CONTRACT CHANGE ORDER NO. _____
SHEET ____ OF ____

MARK	DATE	DESCRIPTIONS	BY	CH'D	CCO#
1	10/20/11	SUSPENDER PROTECTION @ PP 98	GB	JD	200S1
0	10/04/11	SUSPENDER PROTECTION @ PP 98	GB	JD	200S1

SAN FRANCISCO OAKLAND BAY BRIDGE
EAST SPAN SEISMIC SAFETY PROJECT
SELF-ANCHORED SUSPENSION BRIDGE
(SUPERSTRUCTURE & TOWER)

CABLE BAND DETAILS NO. 6

SUSPENDER PROTECTION AT PP 98 (See Note 1) (EB shown, WB similar)
1:20

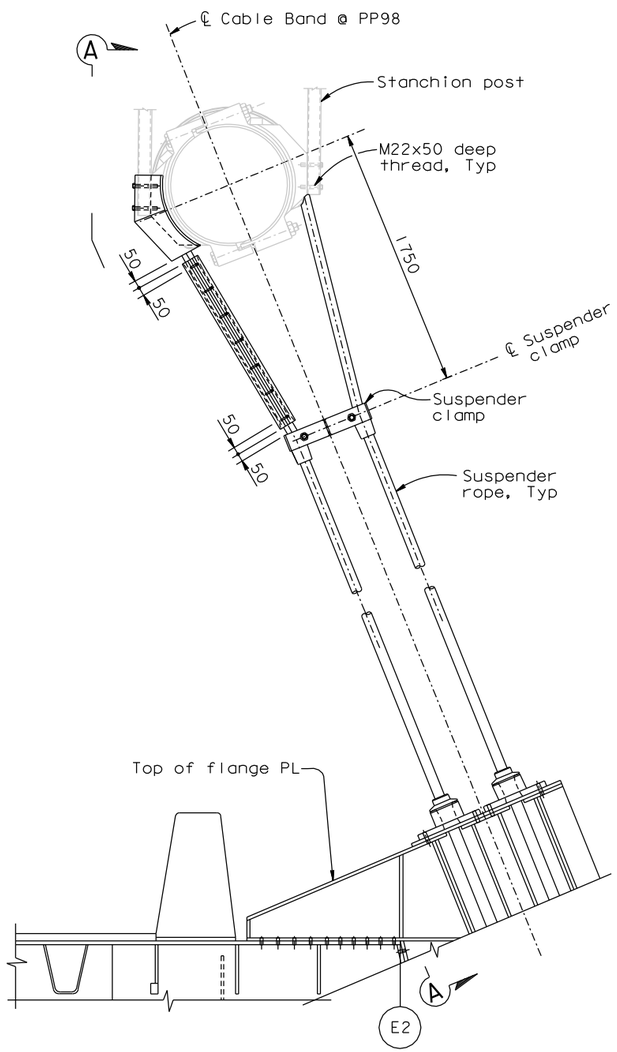
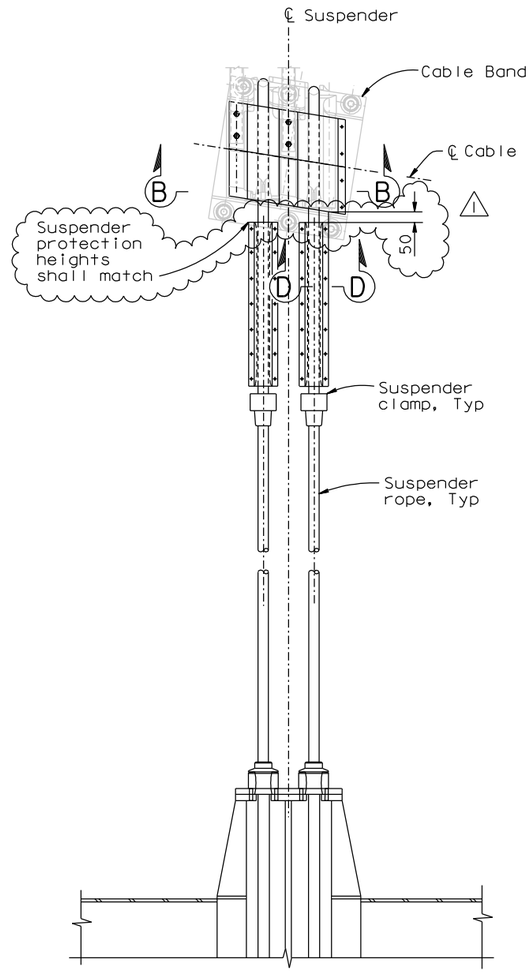
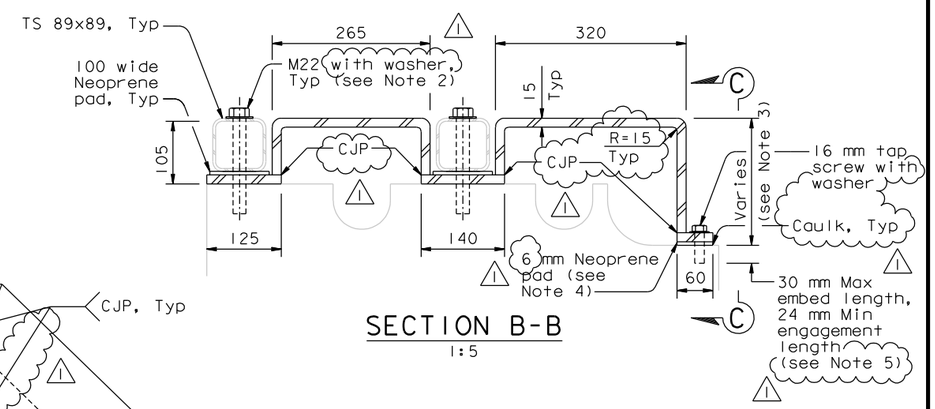
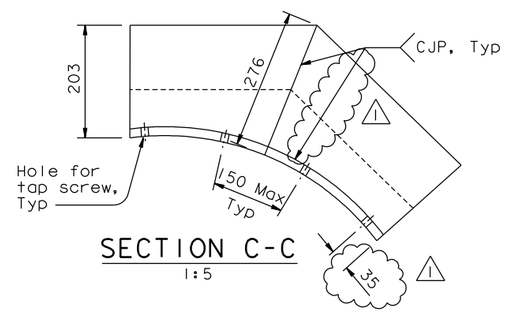
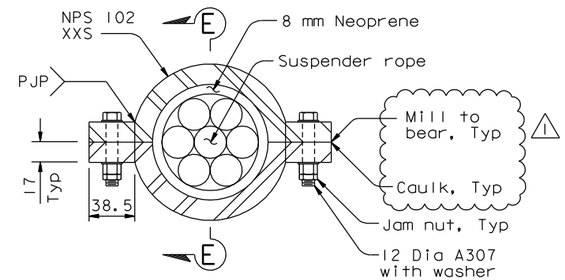
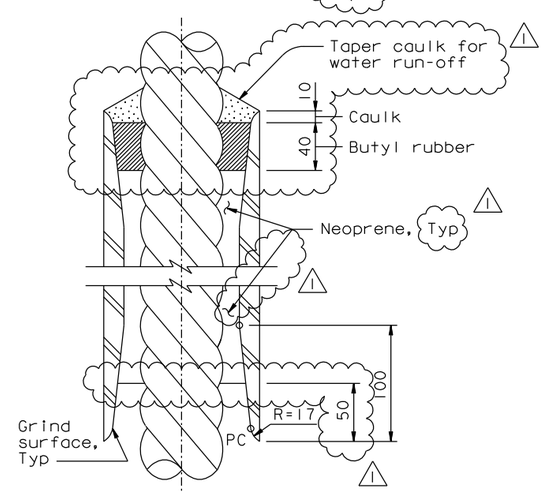
1. If the Department obtains a waiver to reduce the minimum clearance height between the roadway at the interior edge of the barrier and the Cable Band at PP 98, the Engineer shall direct the use of the suspender protection at PP 98.
2. M22 bolts shall be replaced with new longer M22 bolts.
3. Cable band shall be surveyed and cover plate shall be fabricated to match.
4. When approved by the Engineer, grinding of the cable band may be permitted to allow for a tight fit between the cable band and cover plate.
5. Cable band shall be MT tested after drilling and tapping.
